# Criscuolo Engineering, LLC

**To:** Greater New Haven Water Pollution Control Authority  
**From:** James M. Pretti, Jr., P.E.  
**Date:** 2/12/2020  
**Re:** James Street Siphon Chamber Upgrades Project – Addendum #1  
**CE File No:** 2017.097  
**cc:** file

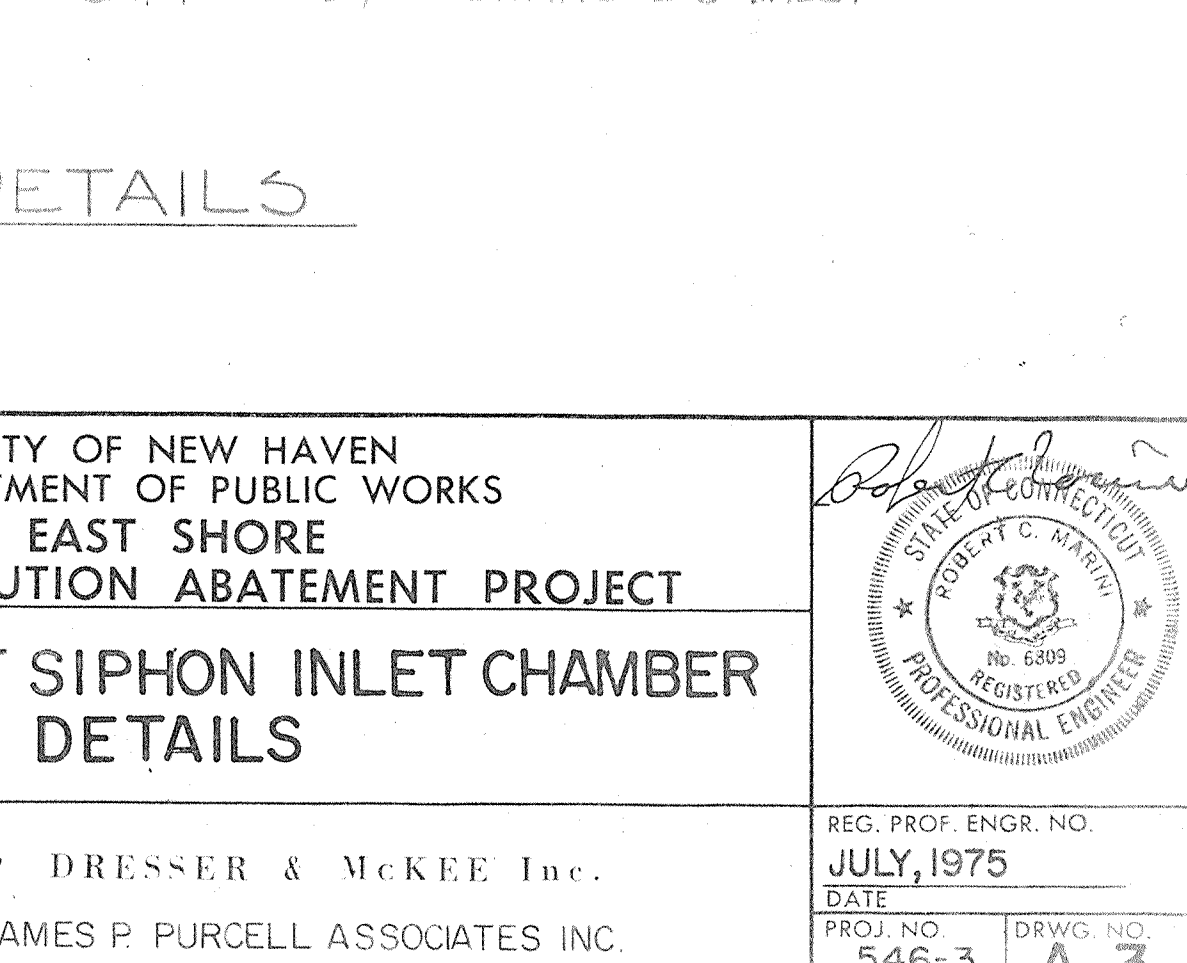
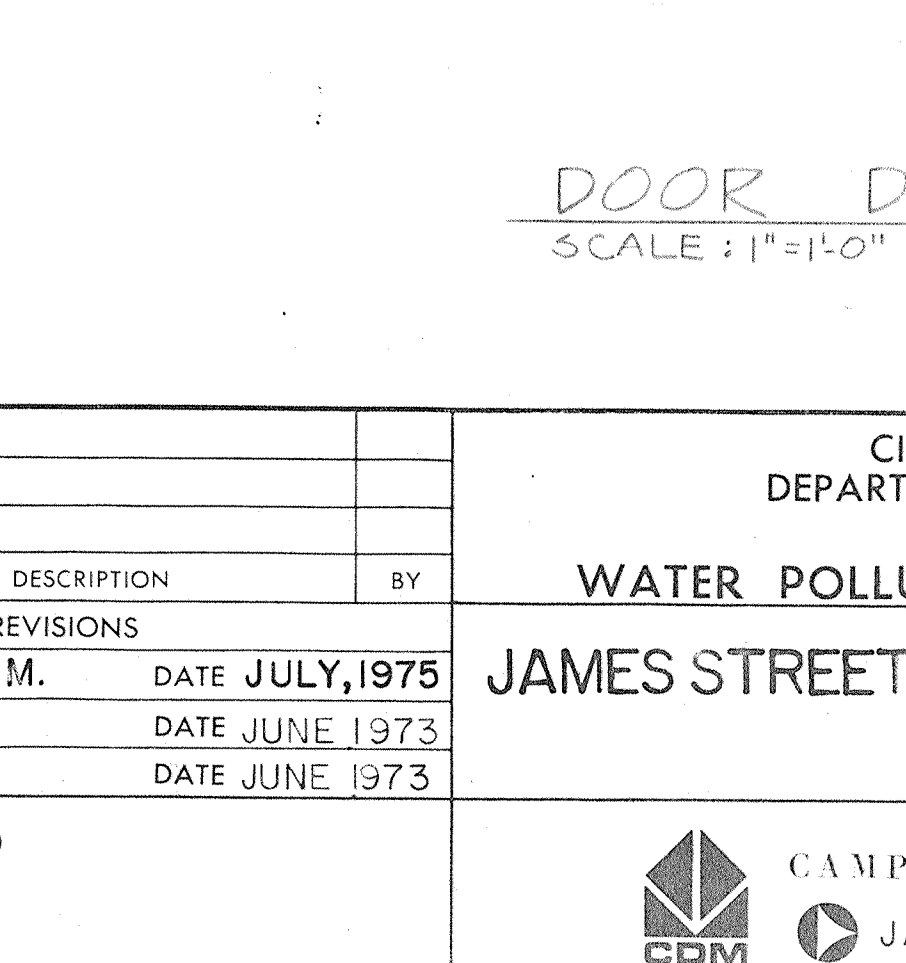
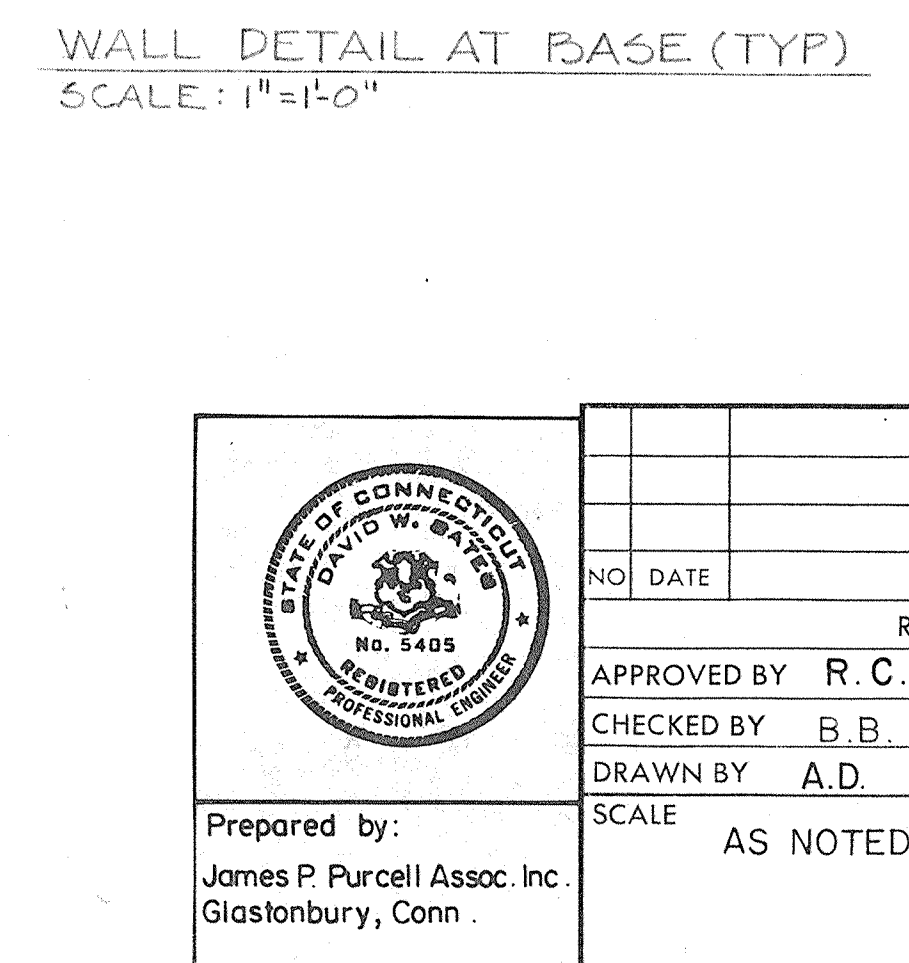
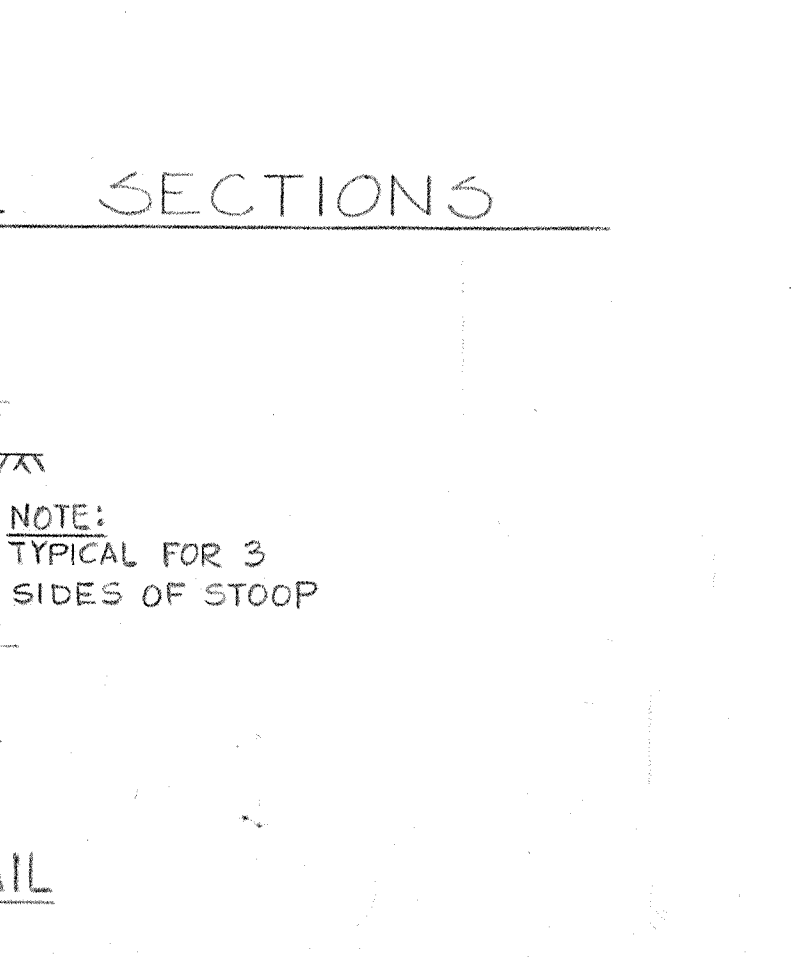
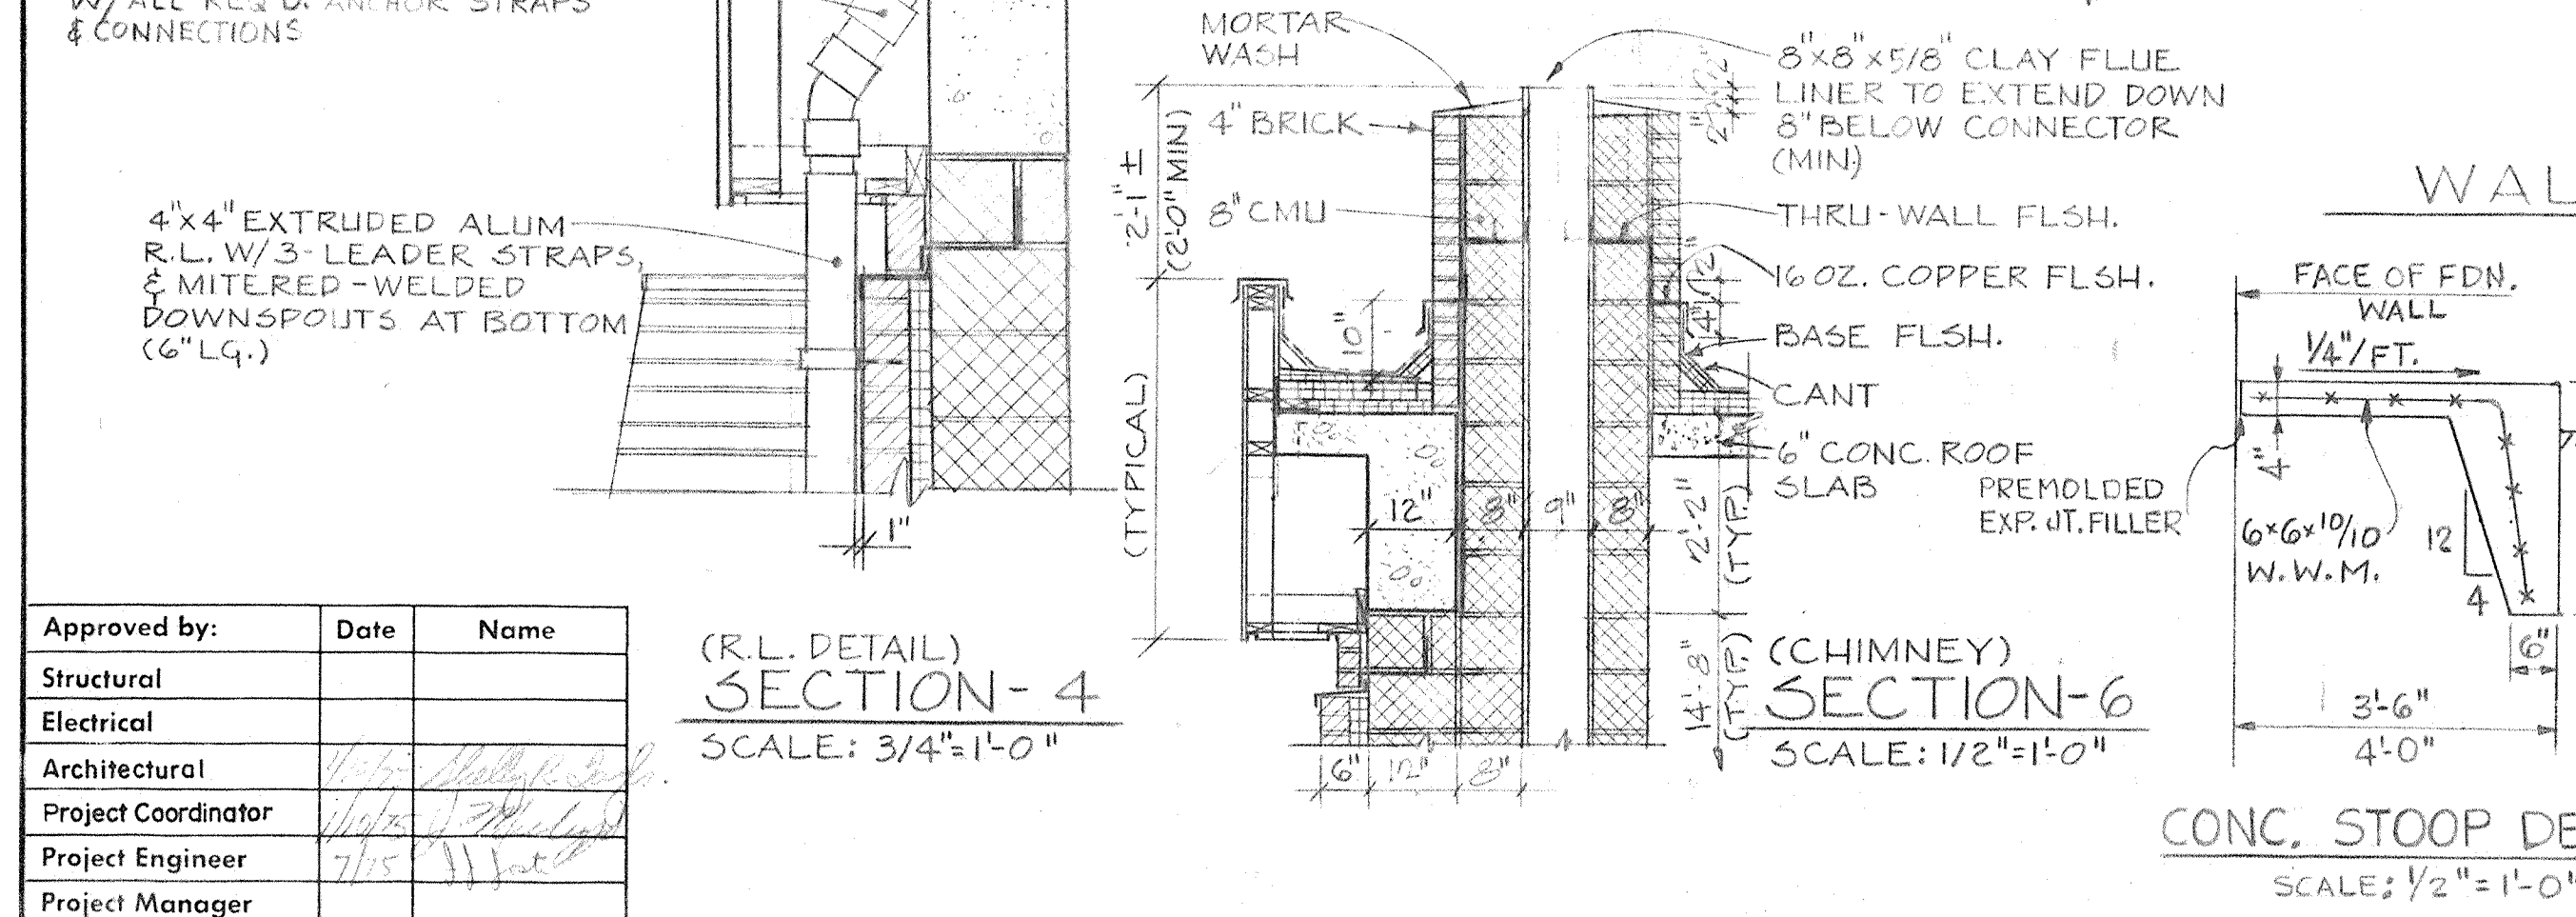
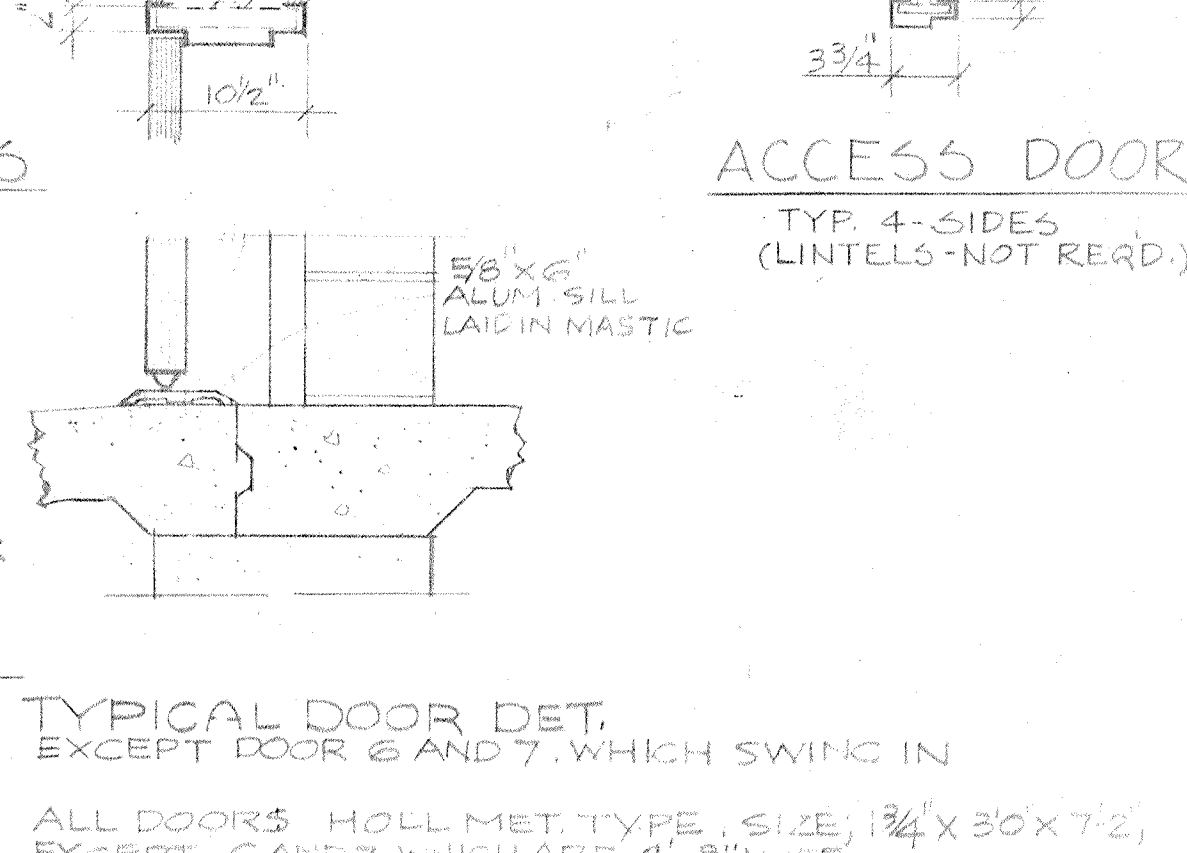
1. a. 1. All existing fascia board is to be replaced. 2. Soffit shall be replaced with fiber cement board as well. 3. There is existing 2x framing behind the existing T-111. The original detail of the framing is included in Sheet A-3 of the original plans. 4. Original plans for the building are attached. 5. The rain cap will need to be removed and replaced for new fiber cement board replacement and rubber roofing installation.
